Oakton College District 535

> Invitation to Bid # 0501-23-10 Addendum #2 Issue Date: May 01, 2023

Oakton Monument Signage - Skokie and Des Plaines Campuses

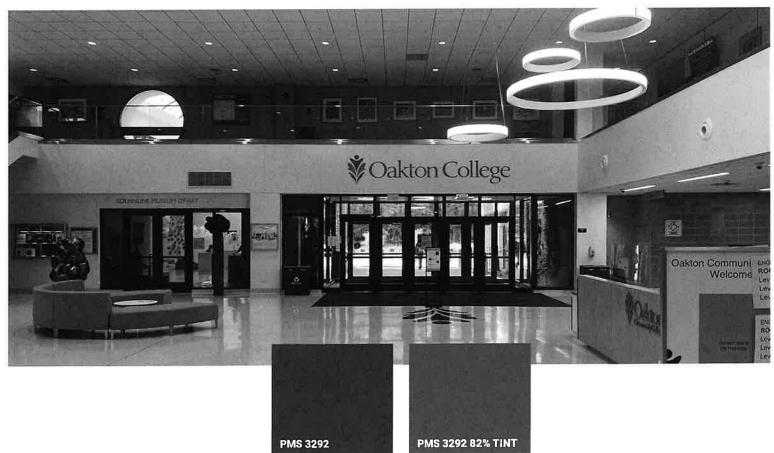
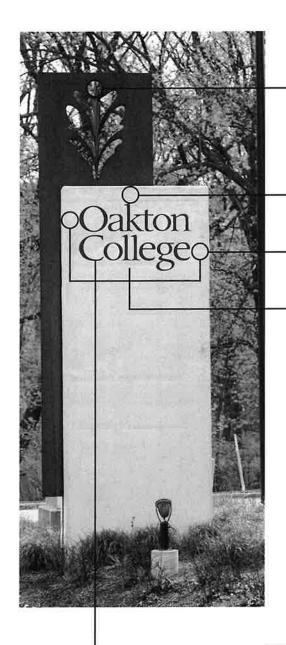
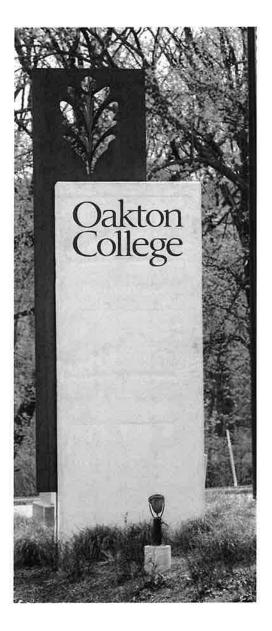
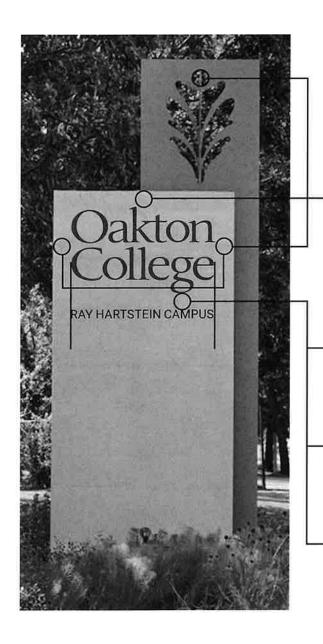
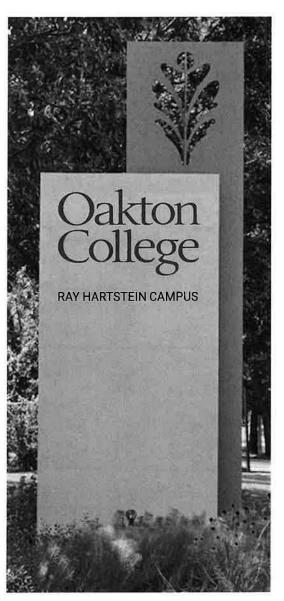
- 1) For the pin letters on the Des Plaines and Skokie concrete monument signs, the specific size of the letters is not called out. To ensure we are all bidding on the same thing, can you please specify the height and thickness of the FCO letters you want?

- a. Please see answer to question 5
- 3) For the inside sign at Des Plaines, can you please indicate the exact location for the new sign, or provide a photo of the wall the letters will be installed? Also please specify the height and thickness of these letters.

- a. Please see the attached design sketches from the College that should illustrate the size of the letting on the monumental signs. Thickness to match existing, please field verify.

- a. Please see attached additional sketches for clarification.
- 4) Do you have the radius of the curved signs from the original installation? If so, can you please provide that?

Spacing from top, bottom equal to 2 Circles of leaf

Oakton Horizontal Logo with Leaf to be centered verically and horizontally

Leaf head and wings 82% PMS 3292 and Oakton College 100% PMS 3292

Spacing on top, right and left equal to 1 circle of leaf

Spacing centered on both left and right sides

Oakton College to appear in PMS 3292

Oakton College to appear in PMS 3292

Ray Harstein Campus to appear in PMS 446

Ray Hartstein Campus to be set in Roboto Regular All Caps

Spacing from bottom of G to top of Caps is equal to 1 circle of leaf

Type alignment should justify left and right to C and e of College above.
